City of Mississauga Department Comments

Date Finalized: 2024-06-05	File(s): A251.24 Ward: 10
To: Committee of Adjustment	
From: Committee of Adjustment Coordinator	Meeting date:2024-06-13 1:00:00 PM

Property Address: 3233 Cactus Gate

Appendix 1 – Transportation and Works Comments

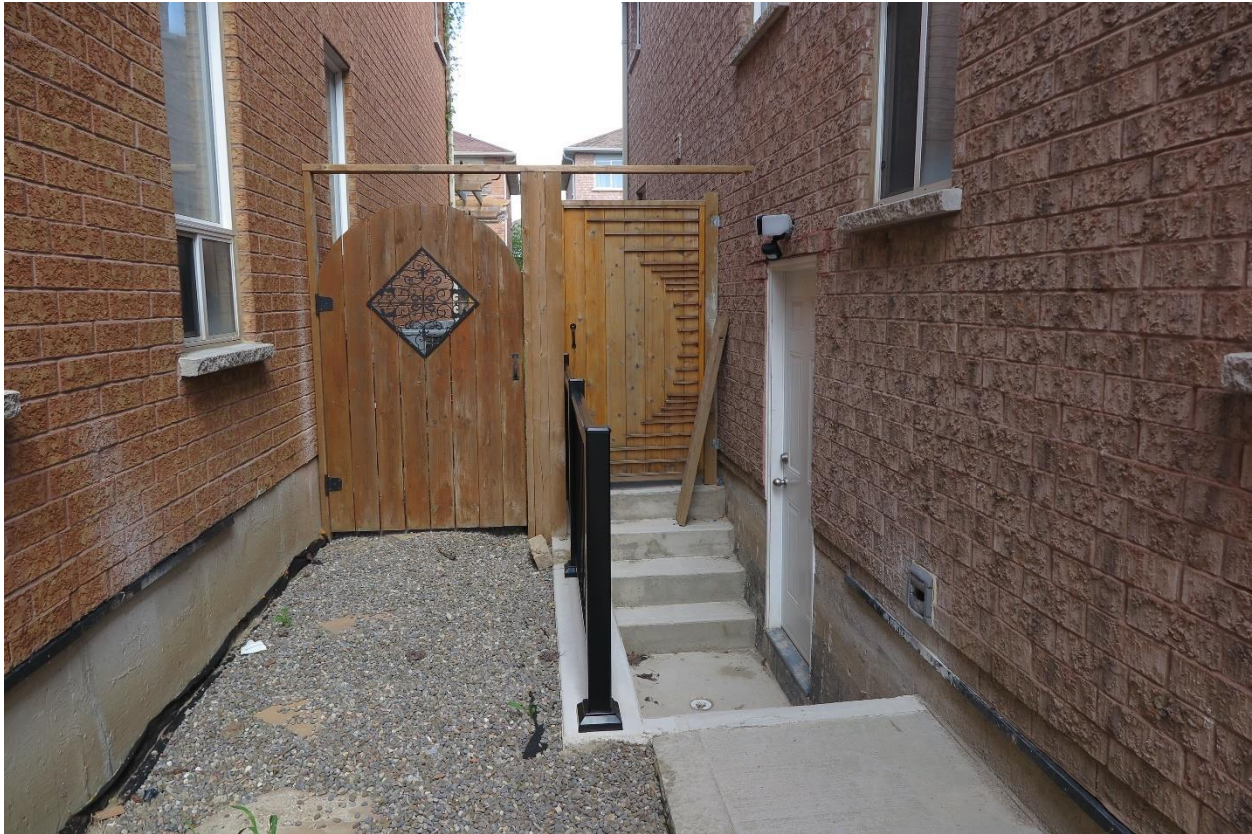
We note that this property has a split drainage pattern, which means that the high point is approximately in the middle of the dwelling in the area of the entrance stairwell. With the minimal 0.11M setback requested, a drainage swale would not be functional; however, in this instance, we do not foresee any significant concerns as the entrance is located at the high point and drainage could still be directed to both the front and rear of the dwelling.
